TELECOMMUNICATIONS
F 167 Mod Instr No 1
Army Modification Code M 00201

STATION, RADIO, A14

TECHNICAL HANDBOOK - MODIFICATION INSTRUCTION

SUB-TITLE: Module J - C.W. signal-to-noise ratio

Fig 1 - Ferrite bead and sleeve location

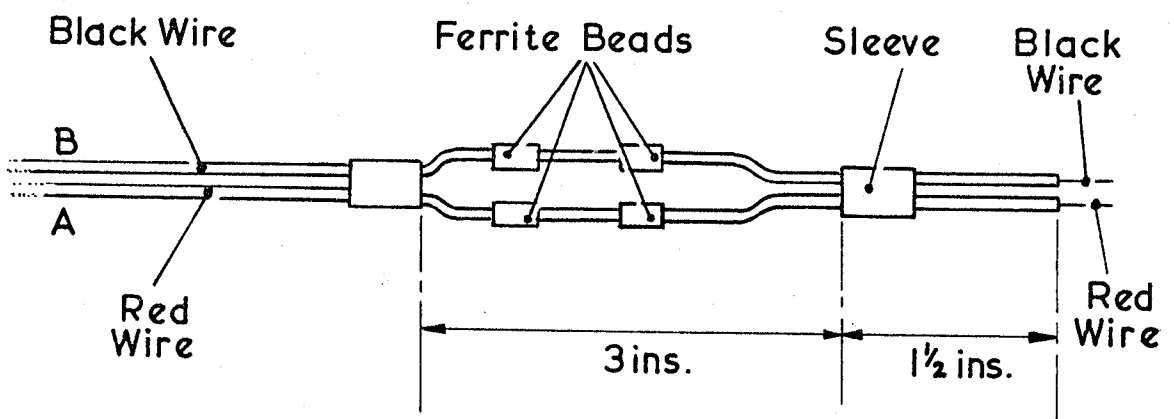
- k. Solder the free end of the black wire fitted in g. to the solder tag provided and secure the solder tag as shown in Fig 2.
- l. Solder the free ends of the assembly made in h. to SKTA, red to pins A and C, black to pins B and D.
- m. Reverse a. to d. inclusive.
- n. Strike through without obliterating the figure 1 on the modification record plate attached to the hand generator.

- a. F 162 Part 2 Page 1056 Fig 2539 (upper diagram). Insert 10 μ F capacitor (circuit reference C3) between RV1 and C2. Insert connections between C3 (+ve) and junction of C2 and C1, and between C3 (-ve) and the pin adjacent to RV1.
- b. F 162 Part 2 Page 1057 Fig 2540. Insert 10 μ F electrolytic capacitor (circuit reference C3) between the junction of R4 and VT3 (-ve lead of capacitor C3) and line connecting ZD1 and C1 (+ve lead of capacitor C3). Insert L1 and L2 (ferrite beads) in output line between R9 and SKTA pins B and D. Insert chassis symbol between R9 and L1. Insert L3 and L4 (ferrite beads) in output line between R7 and SKTA pins A and C.

Fig 1 - Drilling and wiring detail

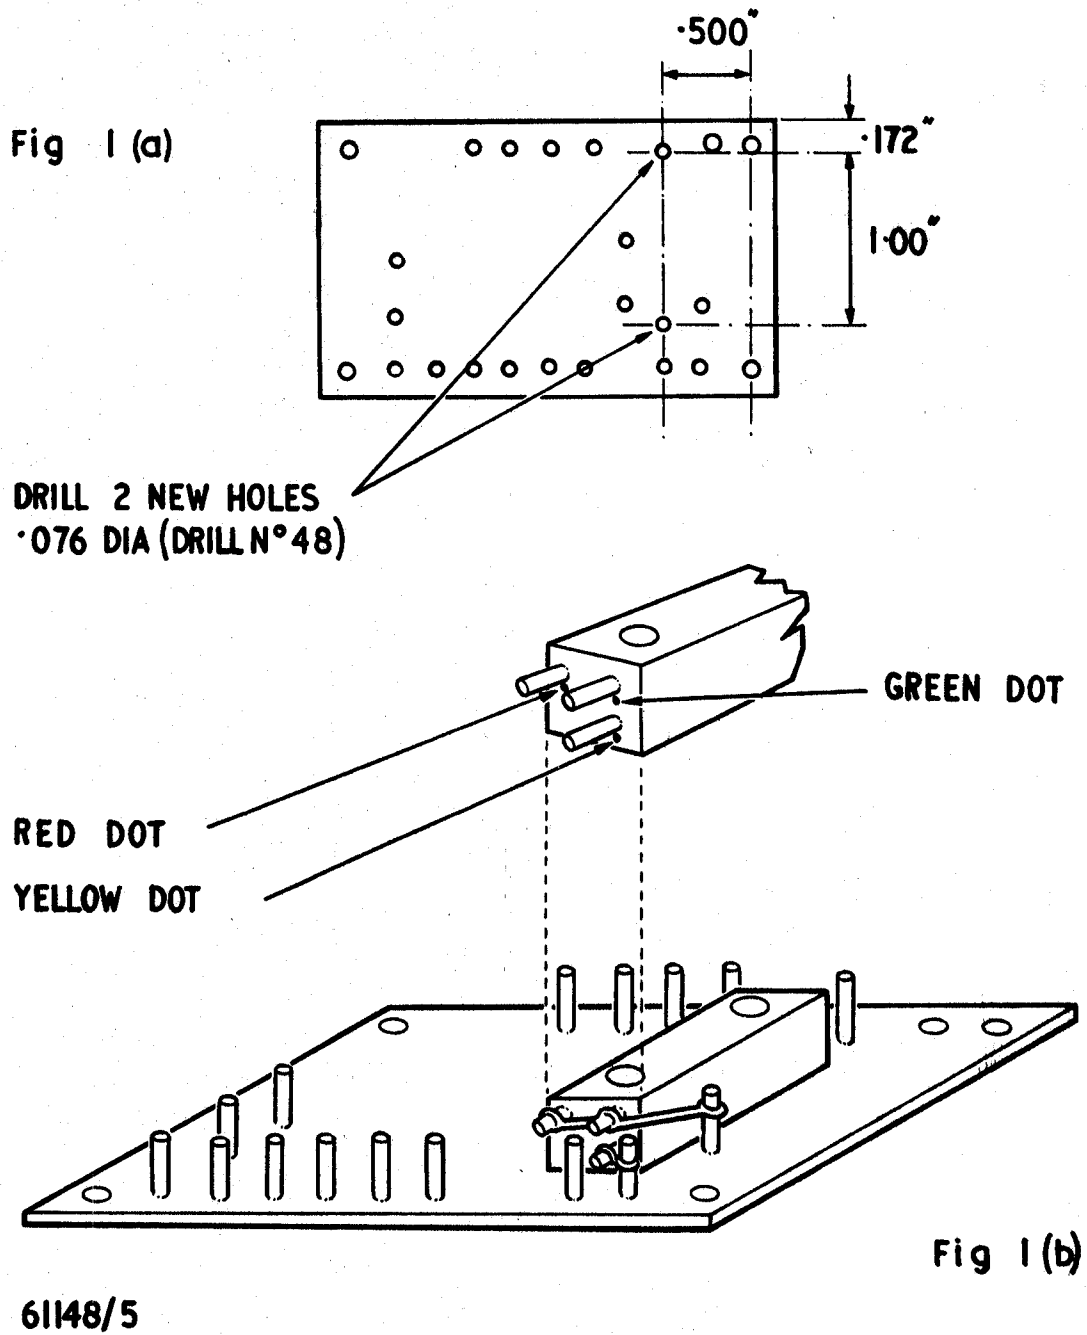
- a. Remove the component board as detailed in Tels F 164 para 54.
- b. Unsolder the red, green and yellow wires of the defective RV1 from their respective terminals.
- c. Remove the two fixing screws and discard RV1.
- d. If the modification has not previously been carried out (ie if RV1 is of the old type), two new fixing holes must be drilled as shown in Fig 1(a).
- e. Solder suitable lengths of 24 s.w.g. wire to the terminal lugs, connecting the red and green terminals together (Fig 1(b)).

- f. Attach RV1 to the board using the two screws removed in c.
- g. Re-solder leads as shown in Fig 1(b).
- h. Replace board on modulator assembly and re-assemble in the amplifier.
- j. Strike out, with a diagonal line, figure 6 from the modification record plate of the amplifier r.f.
- k. The modulator section of the amplifier circuit should be checked and aligned as detailed in F 164 para 125.

- a. Page 1007 Fig 2504 RV1: Delete: '20k' Insert: '25k'
- b. Page 1016 Table 2502, line 10
 - (1) Col 1: Delete: 'Z30/5905-99-106-4105'
Insert: 'Z30/5905-99-112-7531'
 - (2) Col 2: Delete: '20k' Insert: '25k'

Fig 1 -- Location of modification/identification plates

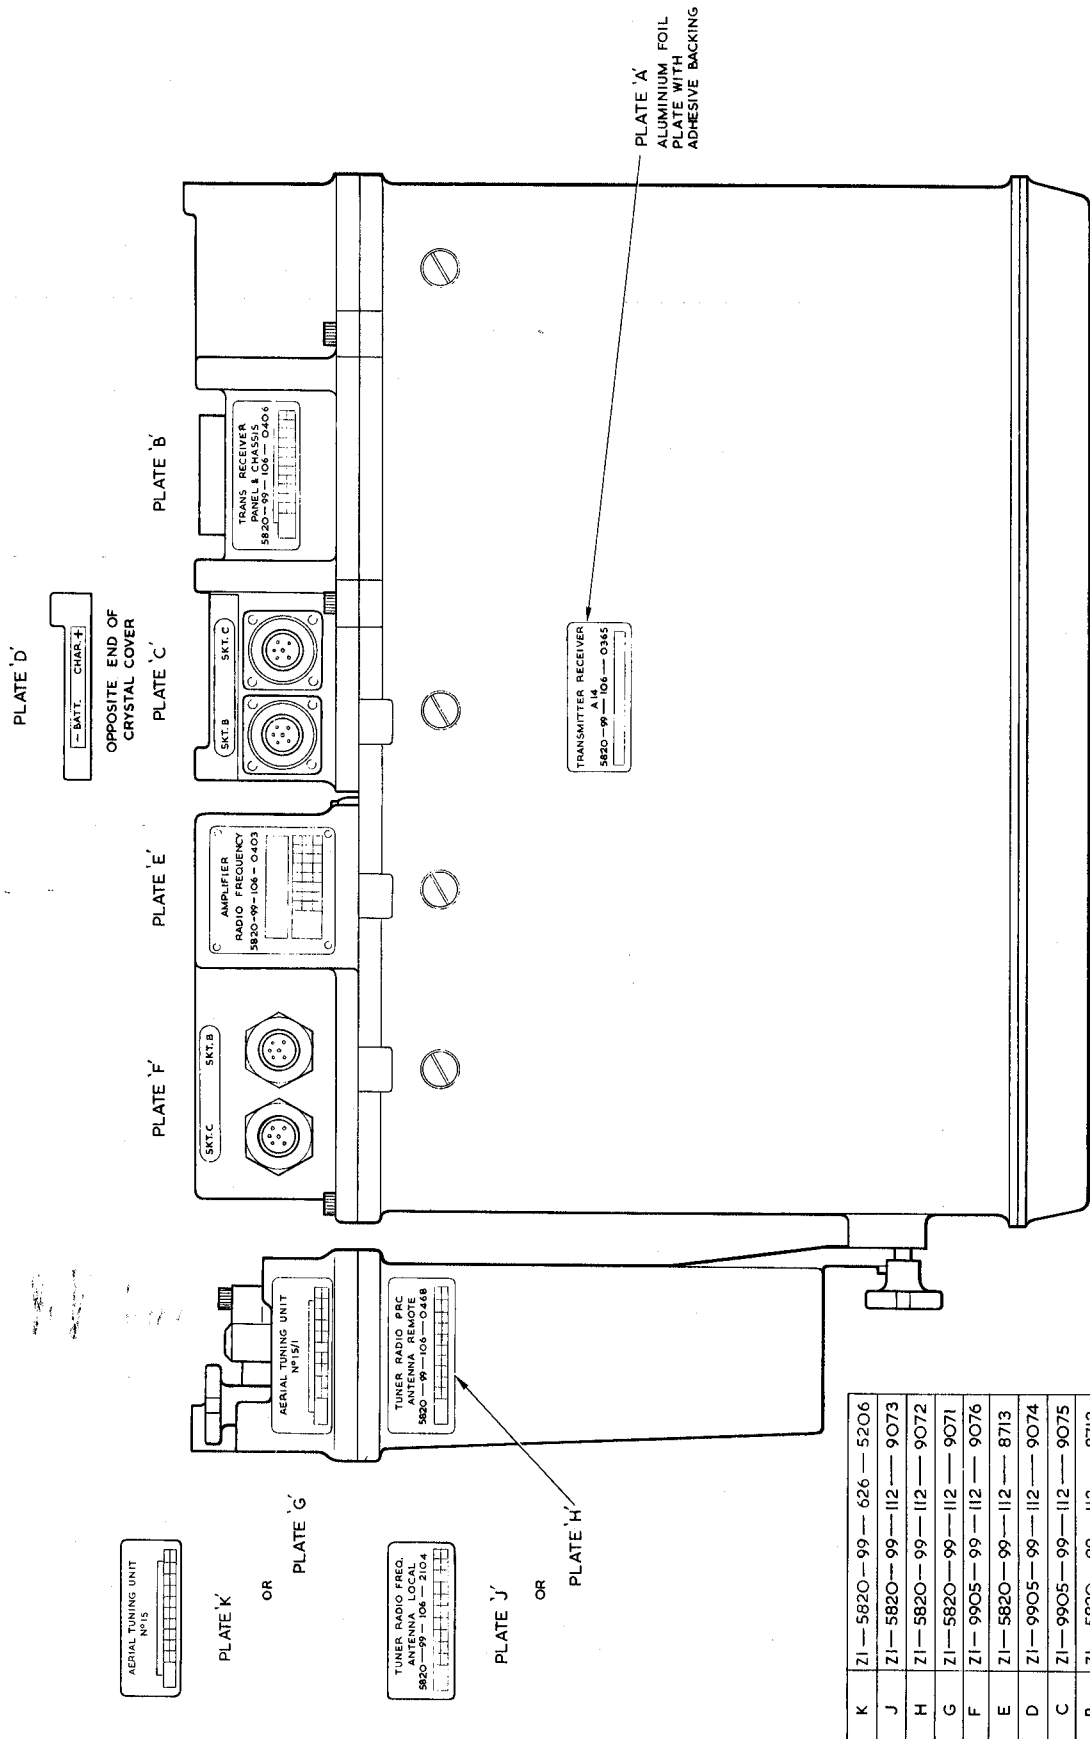
d. Strike through with a diagonal line all modifications appearing on the original modification record label. Record the embodiment of this modification by striking through figure 15. Secure the replacement plate in position (see Fig 1, Plate B) using the Araldite adhesive. Discard old labels.

e. Locate identification labels at SKTB and SKTC. Remove these labels as at b. and discard. Replace with designation plate Z1/9905-99-112-9075 and secure in position (see Fig 1, Plate C) using the Araldite adhesive.

f. Locate identification label at the battery charge sockets. Remove as at b. and discard. Replace with designation plate Z1/9905-99-112-9074 and secure in position (see Fig 1, Plate D) using the Araldite adhesive.

h. Identify replacement modification record plate Z1/5820-99-112-8713. Record serial number and previous modification action as at c. and d. Record the embodiment of this modification by striking through figure 7. Secure the replacement plate in position (see Fig 1, Plate E) using the Araldite adhesive. Discard old labels.

j. Locate identification labels at SKT B and SKT C. Remove as at b. and discard. Replace with designation plate Z1/9905-99-112-9076 and secure in position (see Fig 1, Plate F) using the Araldite adhesive.

Fig 1 - Audio board assembly (pin-board)

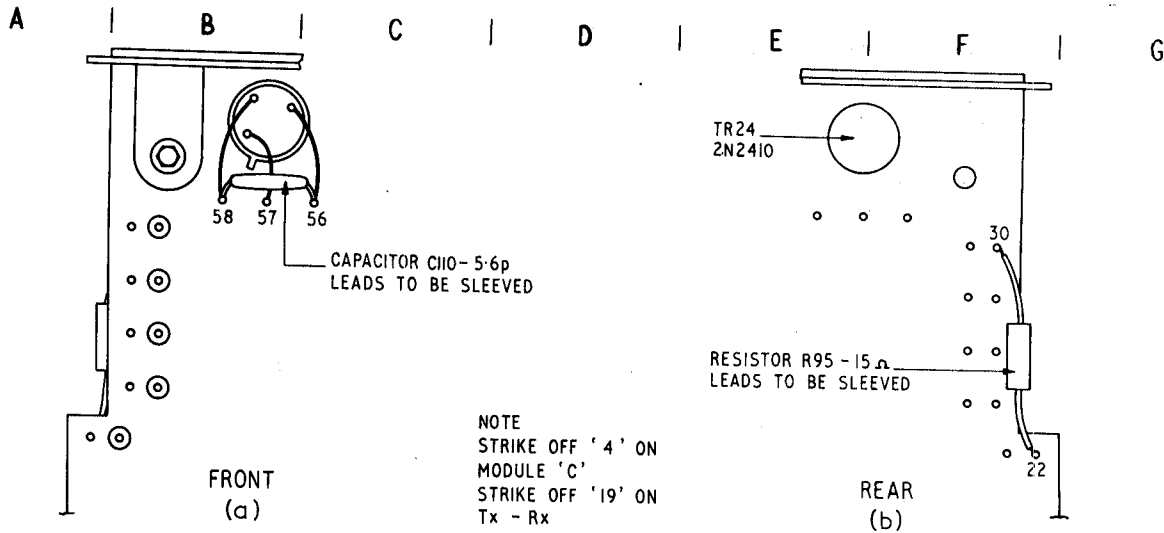
- (1) Remove equipment from its case.
- (2) Remove transistor VT24 (CV7495). Retain the colour coded sleeves and discard the transistor.
- (3) Connect the 5.6pF capacitor (5910-99-106-4028) between pins 56 and 58 as shown in Fig 1.a.

- (7) Solder the 15Ω resistor between pins 22 and 30 as shown in Fig 1.b.
- (8) Replace the module and secure.
- (9) Resolder all leads.
- (10) Strike through with a diagonal line the figure 4 on the modification record label of the module and the figure 19 on the modification record label of the transmitter-receiver A14.

*Note: On embodiment of mod instr No 23 VT24 becomes 2N2410. A new capacitor C110 is connected between base and collector of VT24 and a new resistor R95 is connected between pins 22 and 30.'

Fig 2 - Audio board assembly (printed circuit)

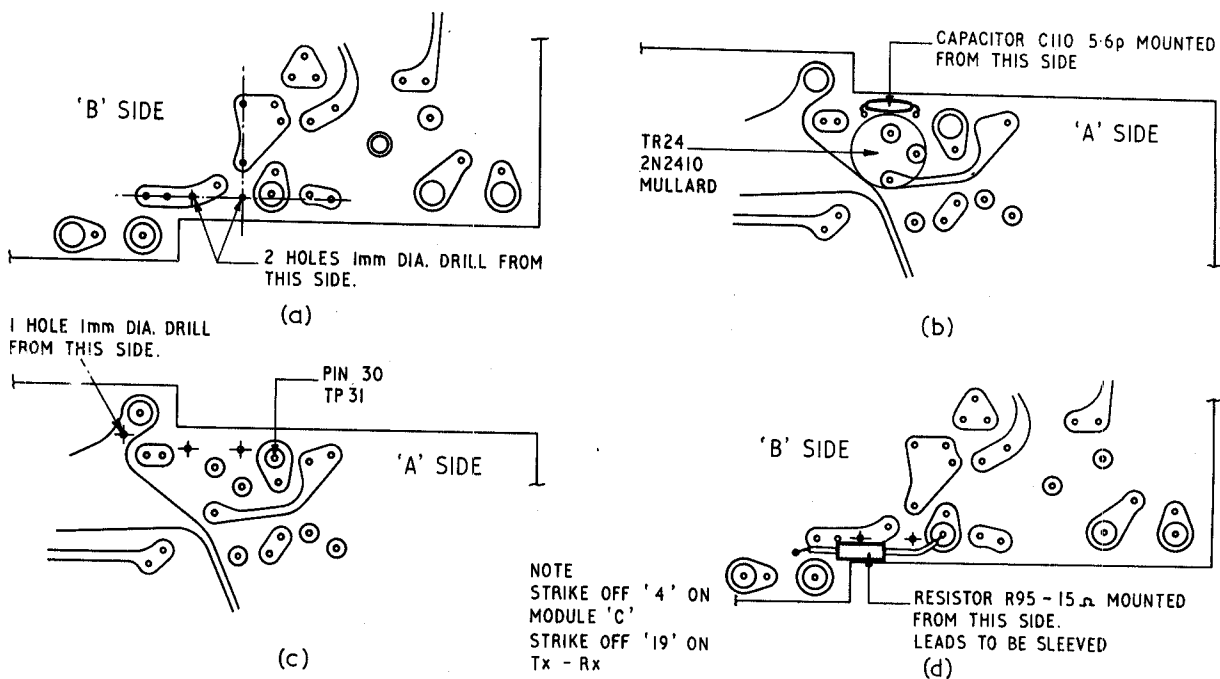
- (1) Remove the equipment from its case.
- (2) Unsolder leads from pins 11, 13, 15, 17, 19, 21, 22, 24, 26, 28, 30, 32 and 33 of module 'C'.
- (3) Remove the four screws securing the module, and expose the trackside of the board.
- (4) Remove TR24 (CV7495) together with mounting pad.
- (5) Place the set on its side and ease the module to obtain a suitable drilling position.
- (6) Drill three holes using 1 mm drill as shown in Fig 2.a. and 2.c.

- (7) Connect the 5.6pF capacitor as shown in Fig 2.b.
- (8) Connect the 15Ω resistor as shown in Fig 2.d.
- (9) Connect the new TR24 2N2410 along with the mounting pad removed in (4).
- (10) Replace the module and secure.
- (11) Re-solder all leads.
- (12) Strike through with a diagonal line the figure 4 on the modification record label on the module and the figure 19 on the modification record label on the transmitter-receiver A14.

Fig 1 - Fitting of sleeving

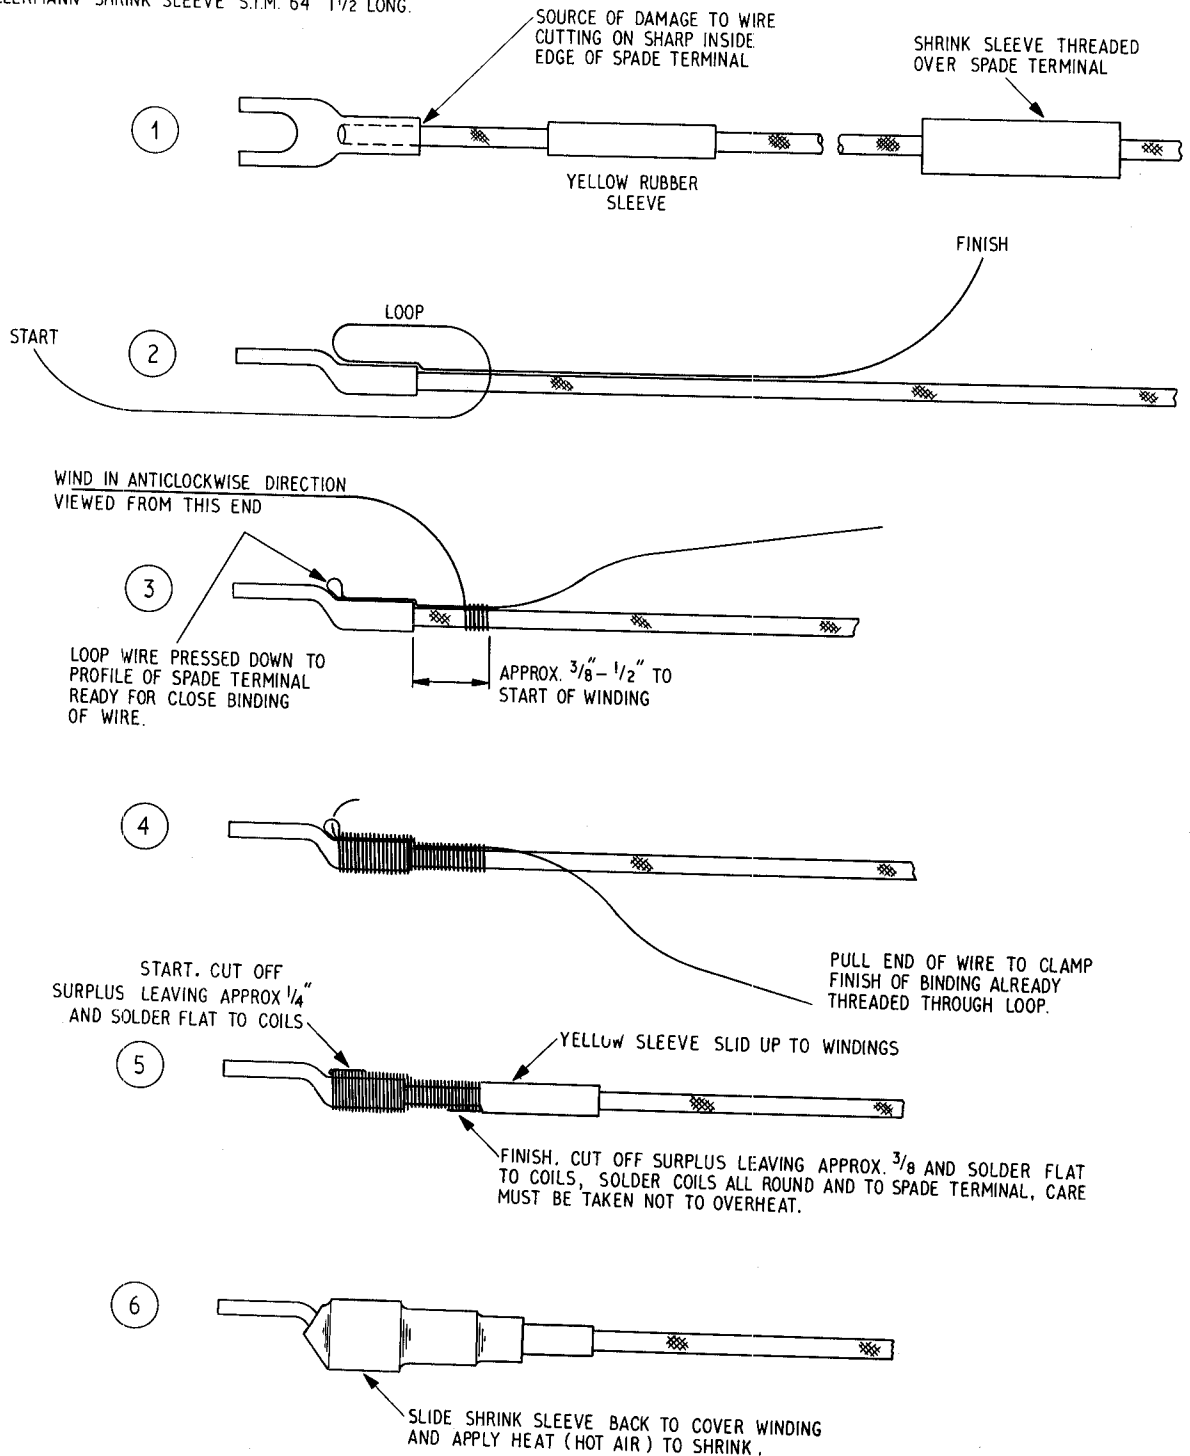
MATERIAL REQUIRED:- WIRE TINNED COPPER 26 SWG
HELLERMANN SHRINK SLEEVE S.T.M. 64 1 1/2" LONG.
